Appl. No. 10/848,747  
Amdt. dated Oct. 29, 2004  
Reply to office action of July 30, 2004

**Amendments to the Drawings:**

**REMARKS/ARGUMENTS**

FIG. 1

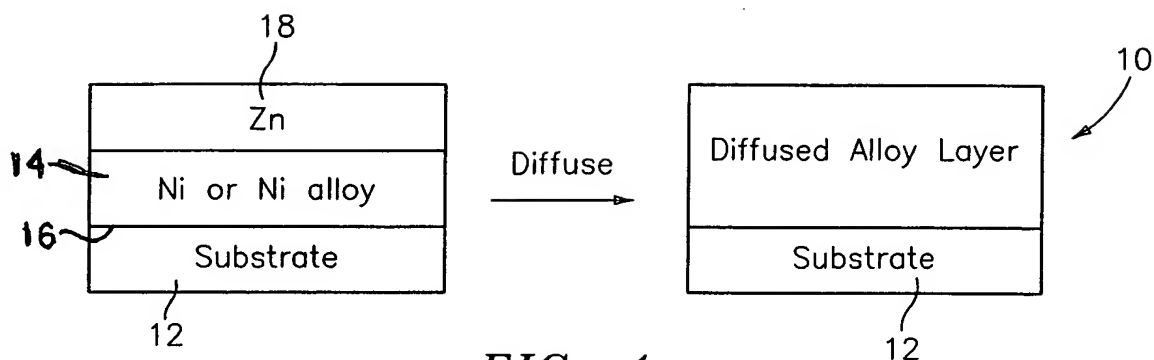
The attached sheet of drawings includes changes to FIGS. 1 and 4. This sheet, which includes Figs. 1, 2, and 4, replaces the original sheet including Figs 1, 2, and 4.

In the office action mailed July 30, 2004, the Examiner raised several objections to the drawings. With respect to FIG. 4, Applicants had previously presented a drawing correction with the Preliminary Amendment which was filed in this case. Not knowing whether this Amendment has gone astray, Applicants enclose herein a replacement sheet of drawings containing corrections to both FIGS. 1 and 4. The Examiner is hereby requested to approve the drawing corrections.
